CITY OF ALBUQUERQUE

Re: West Mesa High School New Classroom Building A
6701 Fortuna Rd NW
Request Permanent C.O. - Accepted
Engineer's Stamp dated: 4/13/2015 (J10D005)
Certification dated: 7-22-16

OVERALL DRAINAGE SITE PLAN

**WEST MESA HIGH SCHOOL
NEW CLASSROOM
BUILDING**

CG-102

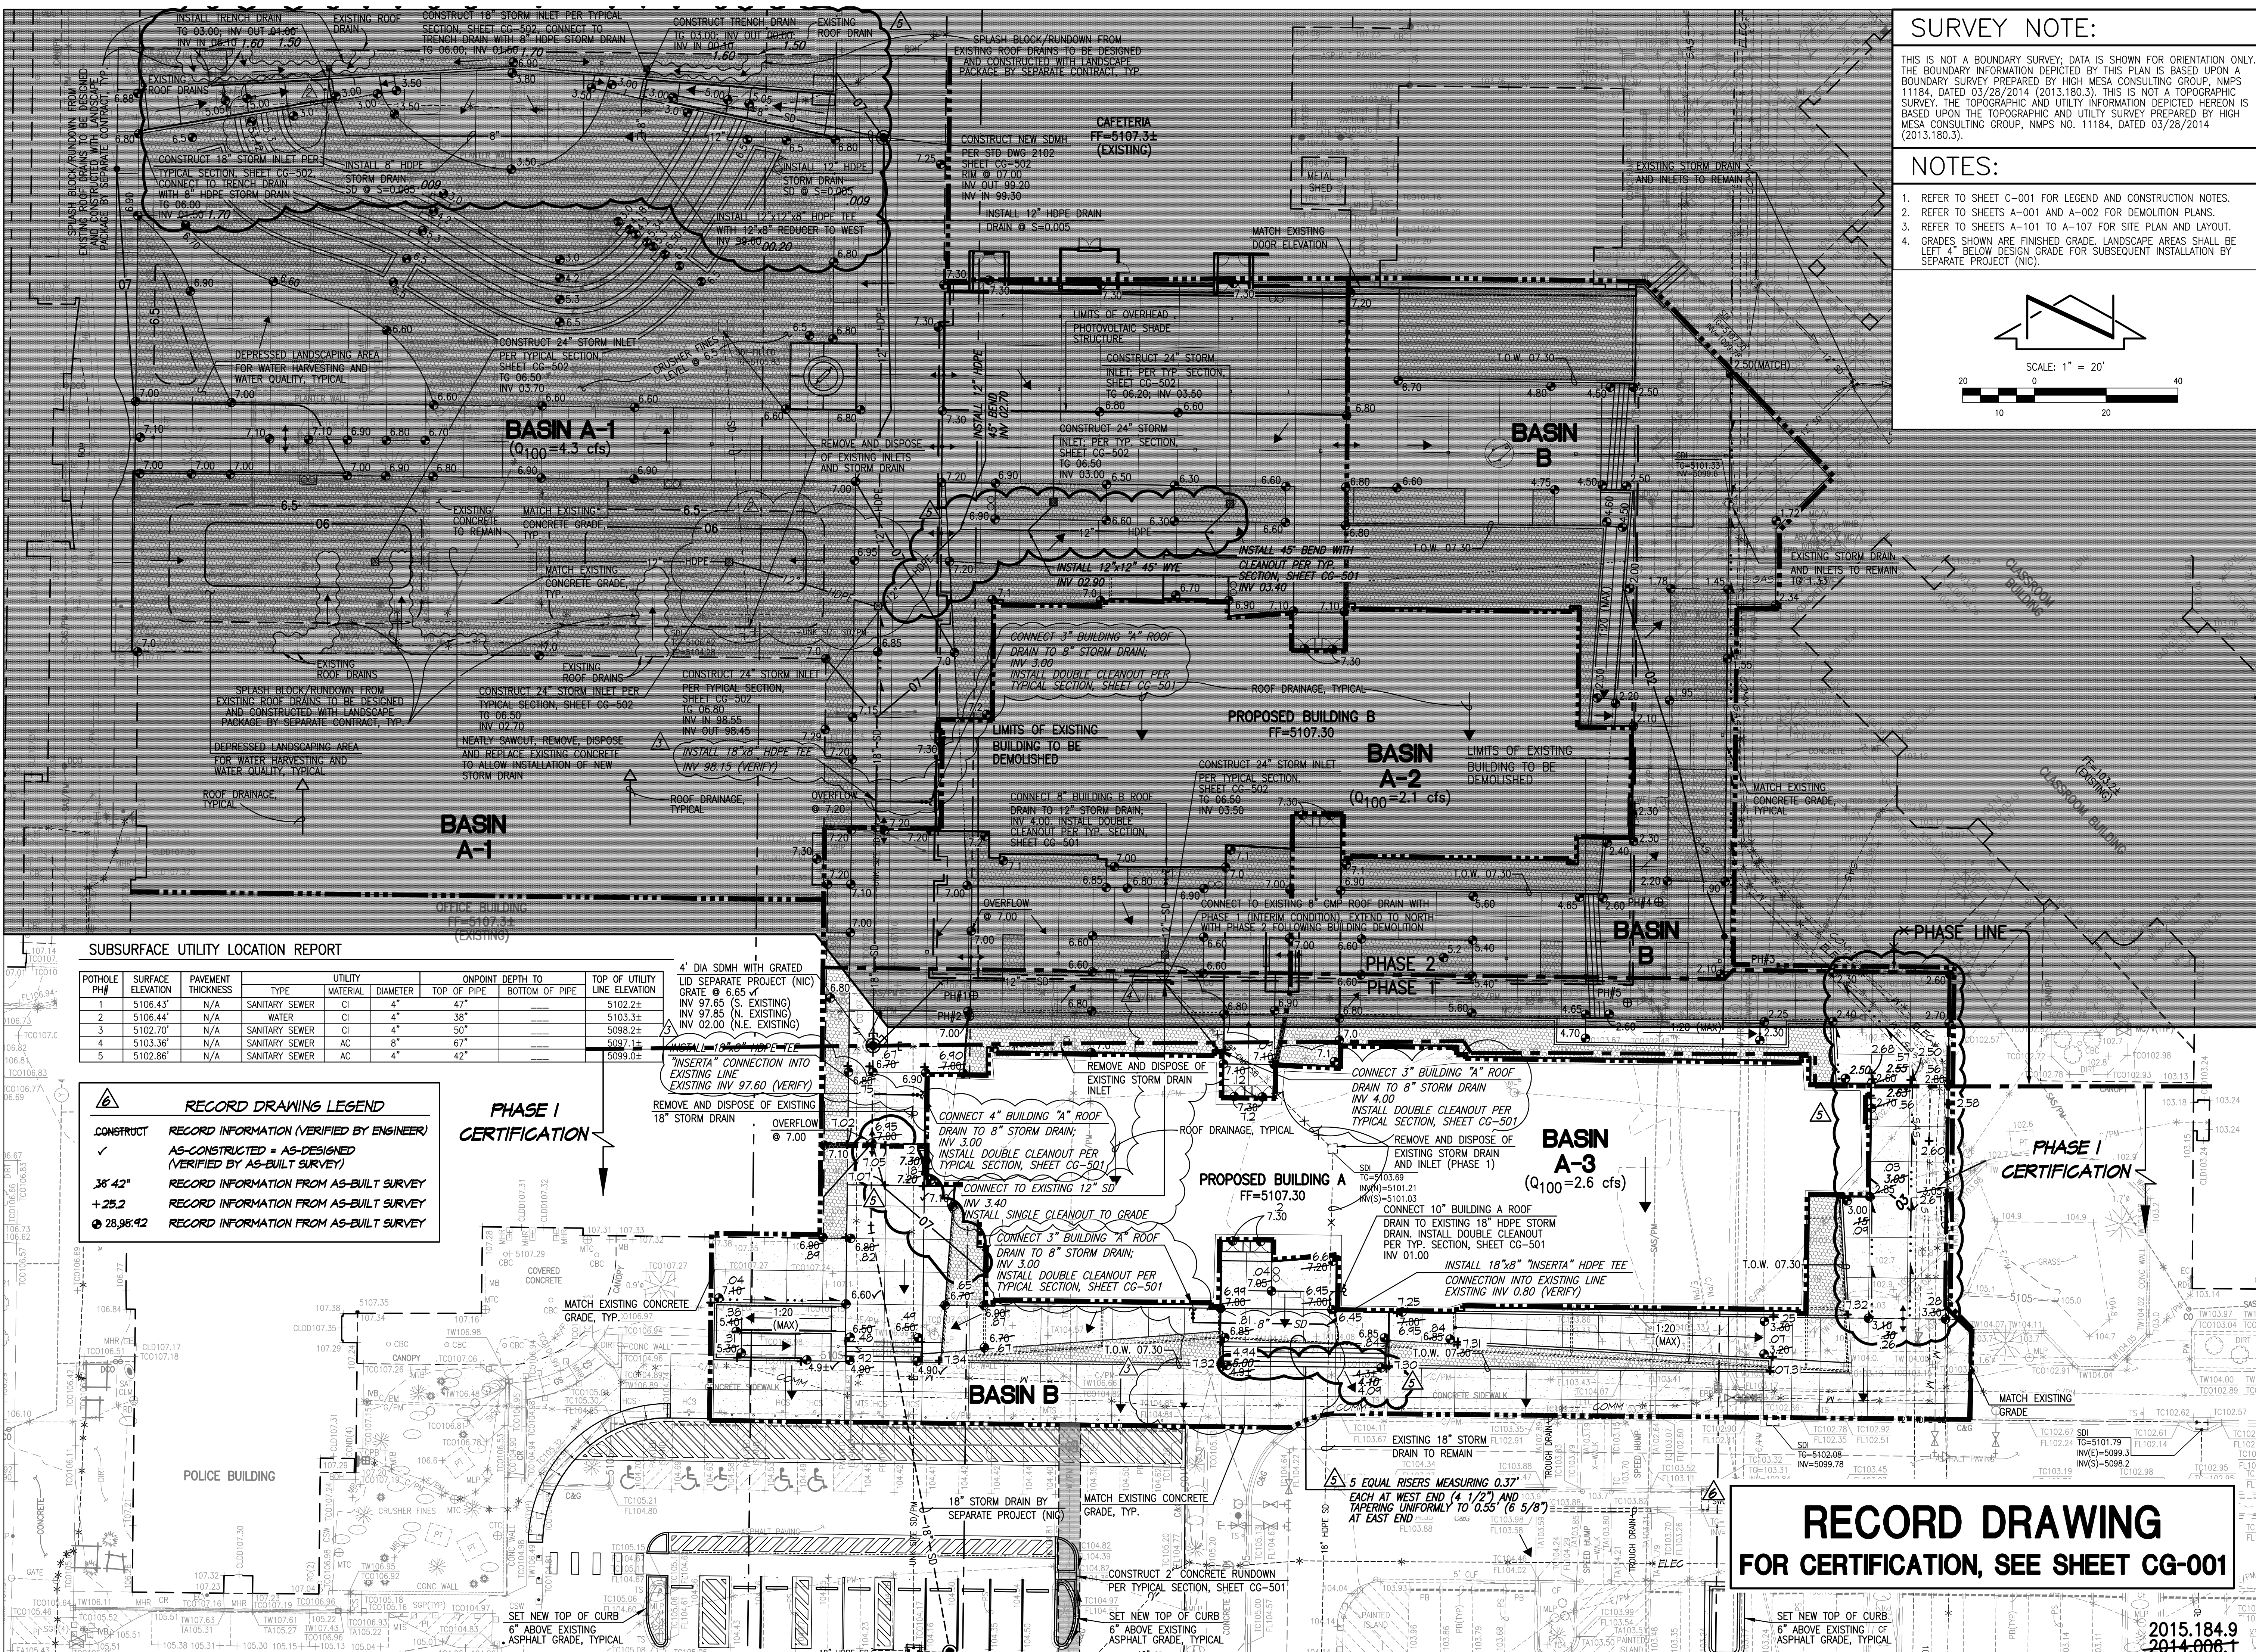
- The North side of New Classroom Building A will remain fenced off during construction of the New Classroom Building B.
- The grated lid at the NW corner of building A will remain swaddled during construction of the New Classroom Building B.
